# RECALL CAMPAIGN BULLETIN

NTB13-035c

## VOLUNTARY SAFETY RECALL CAMPAIGN 2013 PATHFINDER OCS SENSORS

**APPLIED VEHICLES:** 2013 Pathfinder (R52)

## “Lot Code” Flow Chart

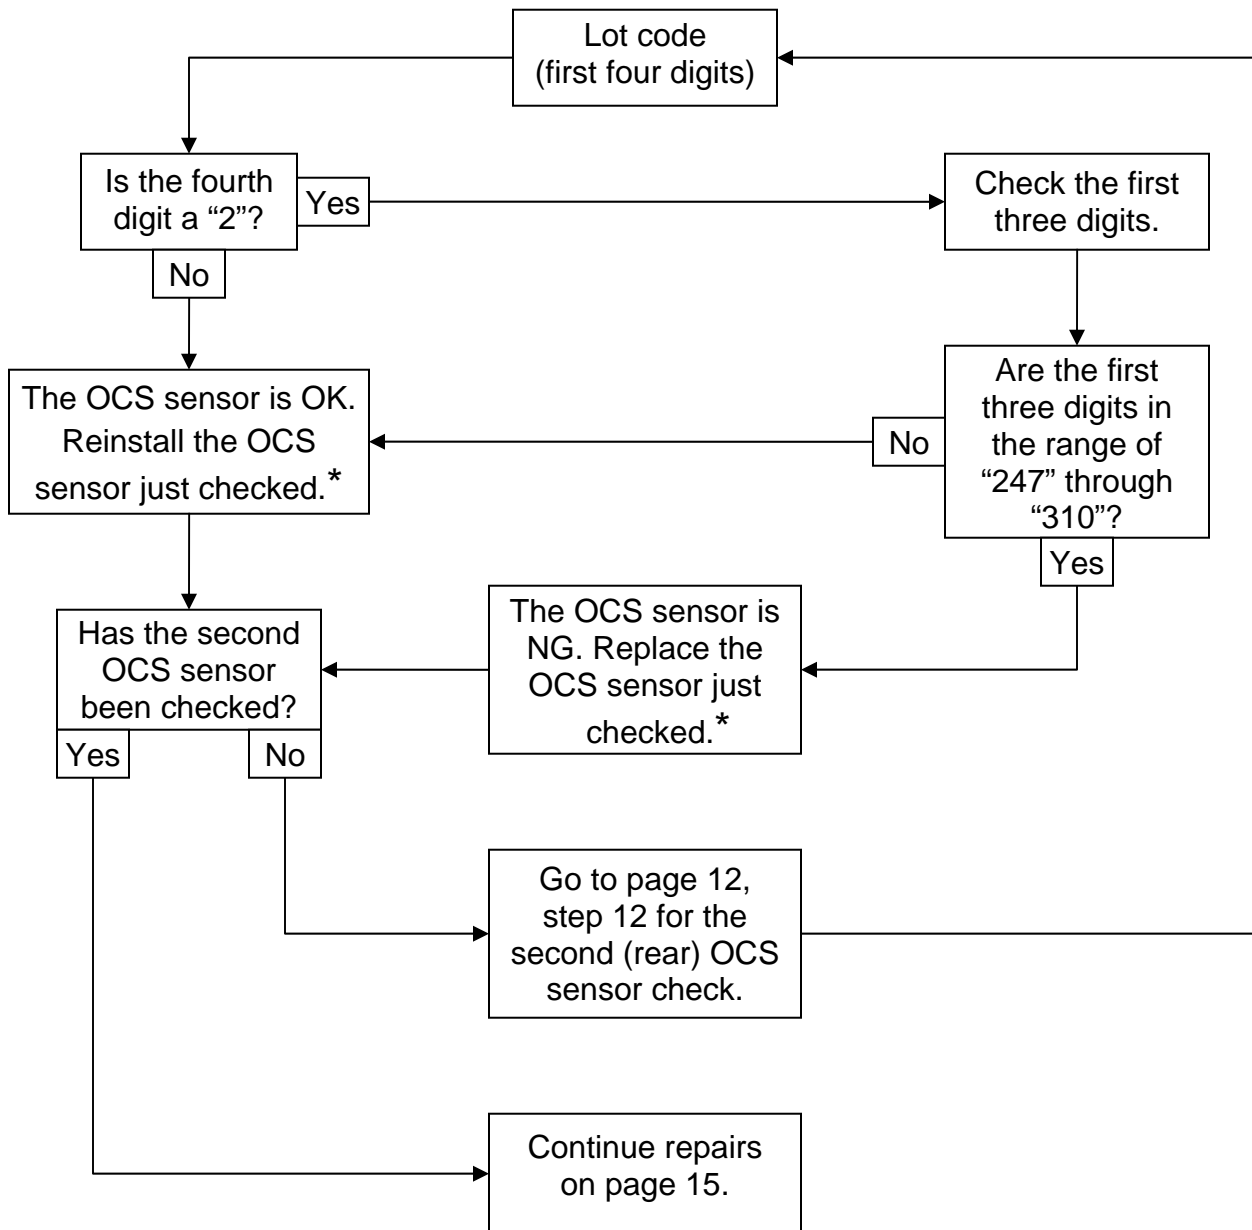
The SERVICE PROCEDURE has been amended. A Flow Chart on page 14 gives further detail on how to more accurately read the OCS sensor lot code number. The Repair Overview has been edited to follow these changes. Please discard previous versions of this bulletin.

\* For front OCS sensor installation (new or original), go to page 11, step 11.  
For rear OCS sensor installation (new or original), go to page 13, step 13.
